SAFETY SOURCE SUBDIVISION, RESUBDIVISION OF

APPLICATION NUMBER 25 DATE October 18, 2007

REQUEST Subdivision

DETAIL SITE PLAN

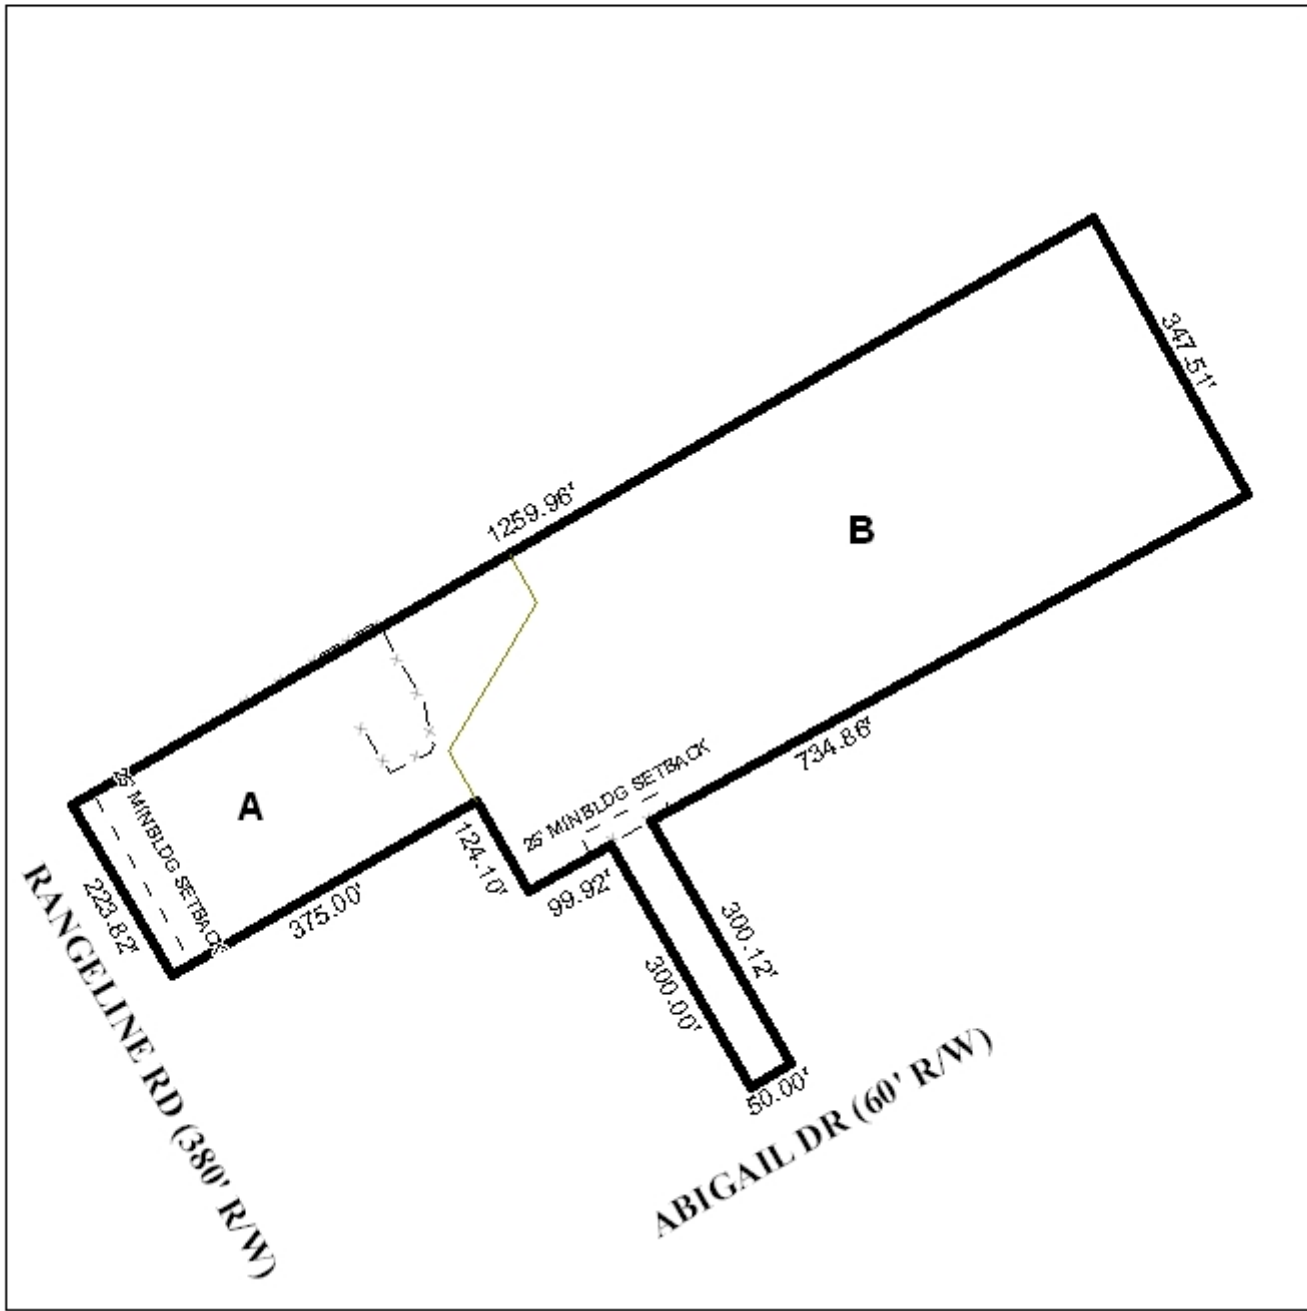
The site fronts onto the service road for Rangeline Road, a proposed major street, and onto Abigail Drive, a minor street with adequate right-of-way. A previous approval in 2002 for Lot A limited it to one curb-cut onto the Rangeline Road service road, and this condition should remain for this application as well. Proposed Lot B should be limited to one curb-cut onto Abigail Drive, however, future subdivision of Lot B may be possible if a street is built on the 50-foot wide portion that connects to Abigail Drive, and dedicated to Mobile County. It should be noted, however, that the Subdivision Regulations would require a proposed street on a 50-foot wide right-of-way to have curb and gutter. The size, design and location of any curb-cuts are to be approved by the Mobile County Engineering Department.

- 1) Placement of a note on the final plat stating that Lot A is limited to one curb-cut onto the Rangeline Road service road, and that Lot B is limited to one curb-cut onto Abigail

Drive, with the size, design and location of all curb-cuts to be approved by the Mobile County Engineering Department;

- 2) Revision of the plat to label each lot with its size in square feet, or placement of a table on the plat with the same information;
- 3) Placement of a note on the final plat stating that no future subdivision of Lot B that results in an increase in the number of lots shall be allowed until additional frontage on a public street is provided;

- 4) Depiction of the 25-foot minimum building setback line on the final plat, as depicted on the preliminary plat;
- 5) Placement of a note on the final plat stating that the development will be designed to comply with the storm water detention and drainage facility requirements of the City of Mobile storm water and flood control ordinances, and requiring submission of certification from a licensed engineer certifying that the design complies with the storm water detention and drainage facility requirements of the City of Mobile storm water and flood control ordinances prior to the issuance of any permits. Certification is to be submitted to the Planning Section of Urban Development and County Engineering;
